ENG-PUDSP20005-R2-PDR-redlines.pdf Markup Summary

Subject: EPC ENG Review

Page Label: 33

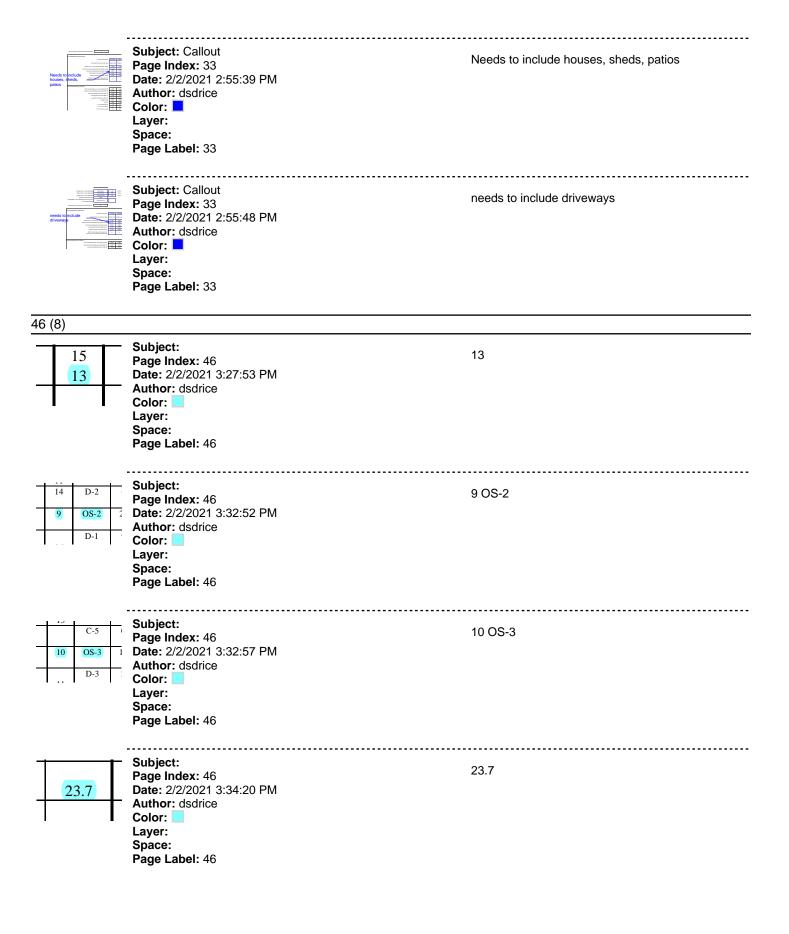
this seems low - should be based on the contributing areas to each pond.
